**TOWN OF NEWBURGH  
PLANNING BOARD  
TECHNICAL REVIEW COMMENTS**

**PROJECT: CHADWICK WOODS SUBDIVISION**  
**PROJECT NO.: 19-02**  
**PROJECT LOCATION: SECTION 14, BLOCK 1, LOT 51**  
**REVIEW DATE: 29 JULY 2020**  
**MEETING DATE: 6 AUGUST 2020**  
**PROJECT REPRESENTATIVE: TALCOTT ENGINEERING/CHARLES BROWN**

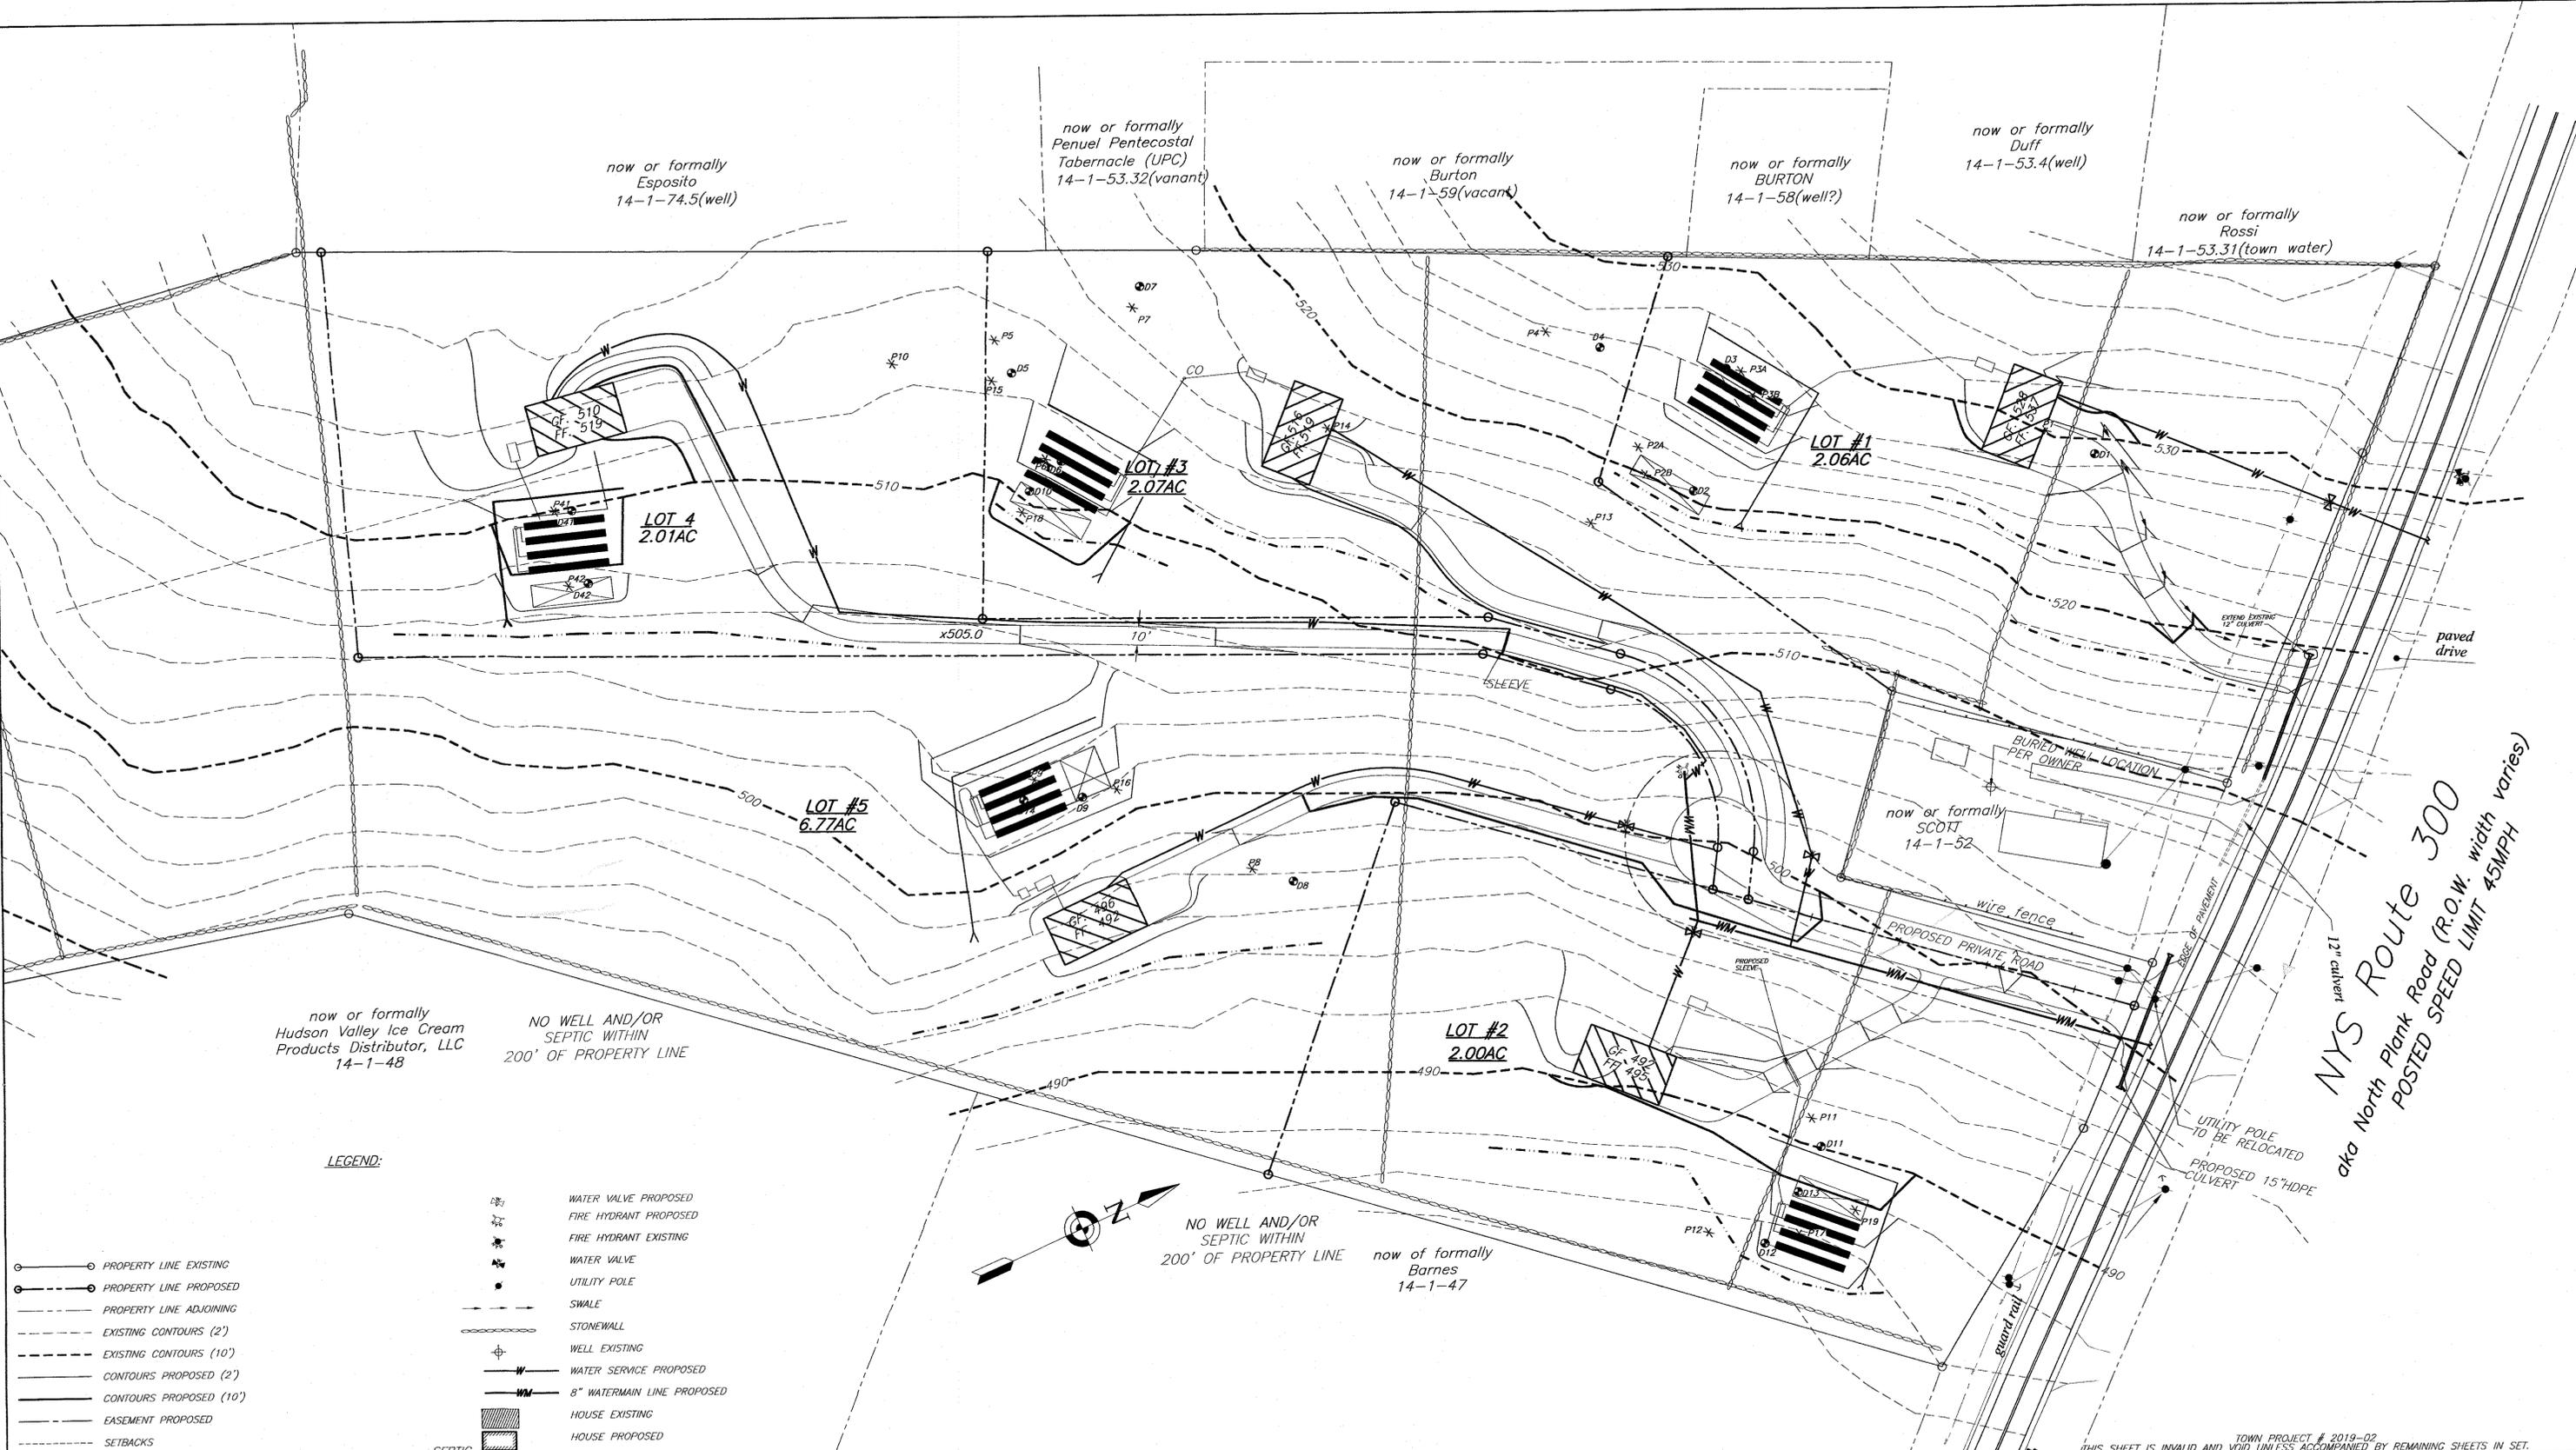
15. Sheet 1 of 6 should have proposed common driveway easement changed to proposed private road easement.
16. A labeled building envelope on all lots.
17. Detail of tapping sleeve and the valves should be provided.

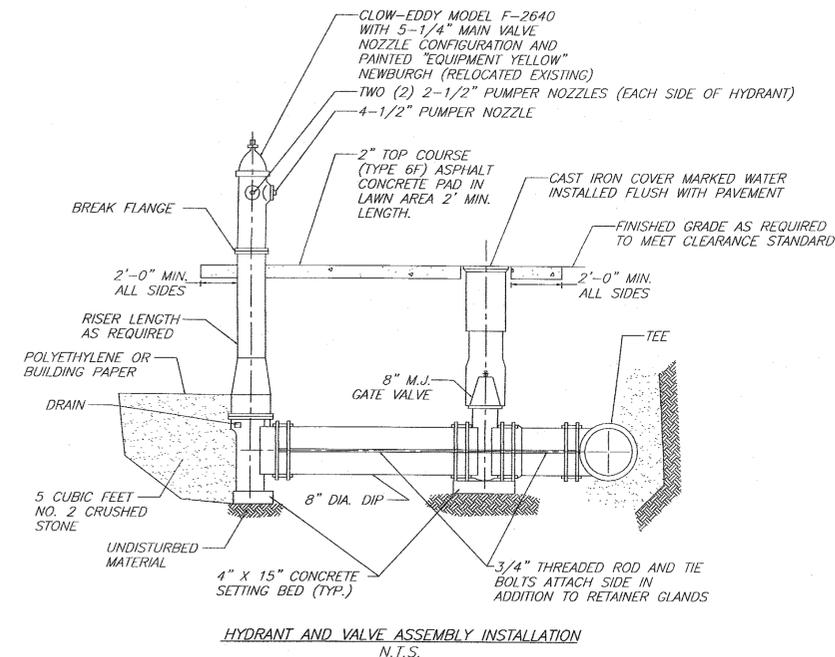
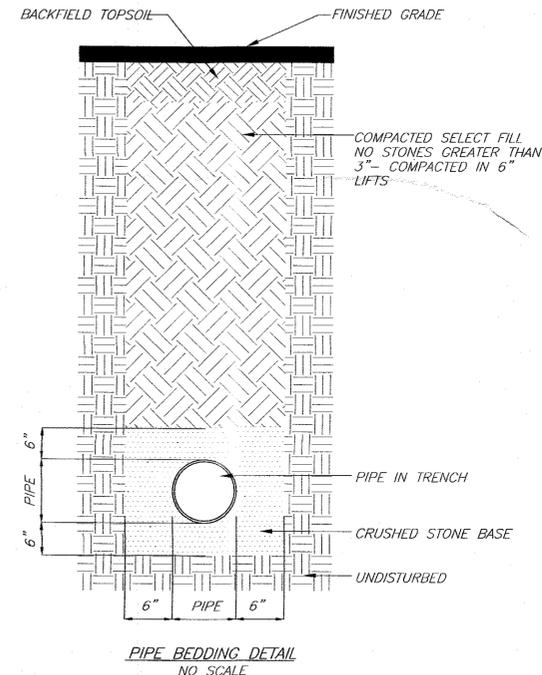
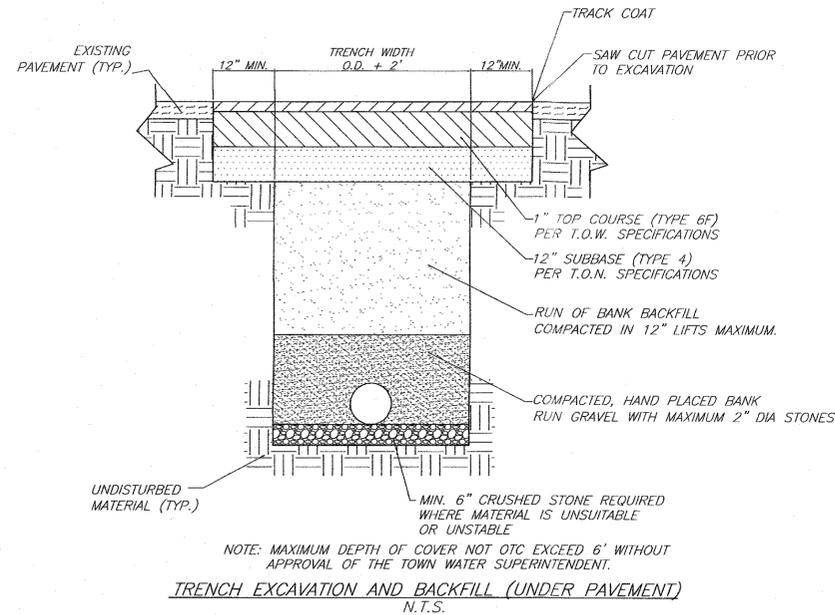
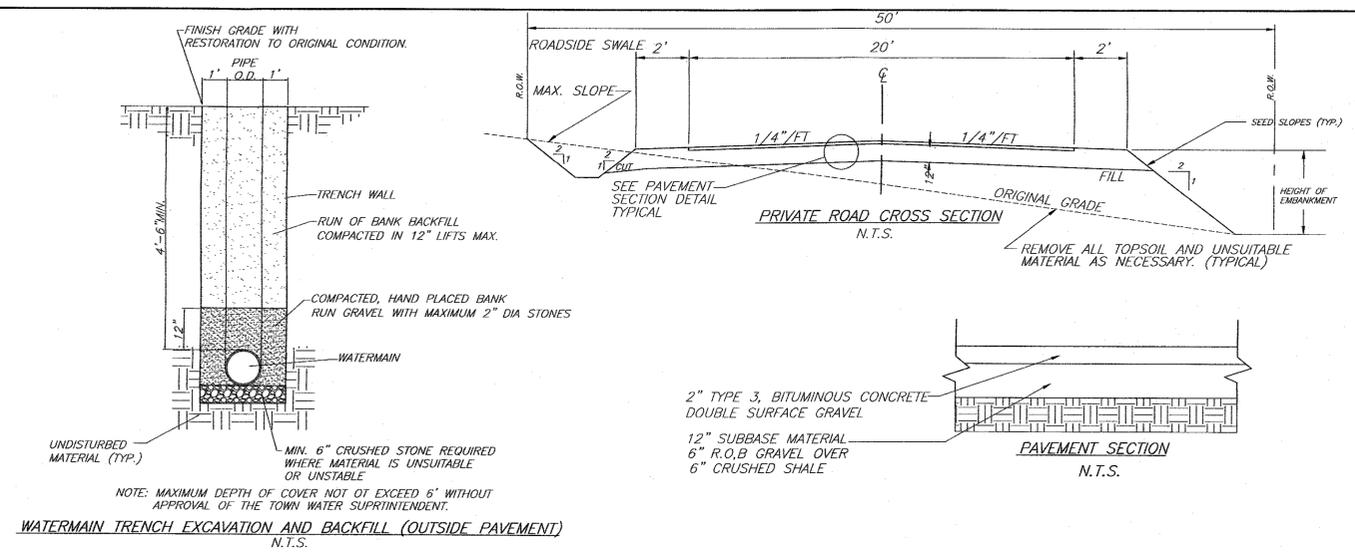
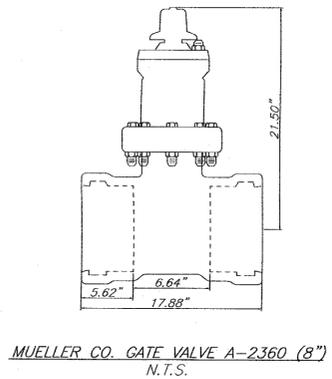
9. Hydrant detail identifies that a hydrant is proposed to be relocated. It is unclear where the relocated hydrant is on the plans. Location of all proposed gate valves must be depicted on

the plans. Details of the proposed wet tap must be included on the plans.

10. Hydrant detail should address if the proposed hydrant drain is below groundwater level.
11. Water Department comments regarding the water line installation should be received including confirmation of hydrant specified.
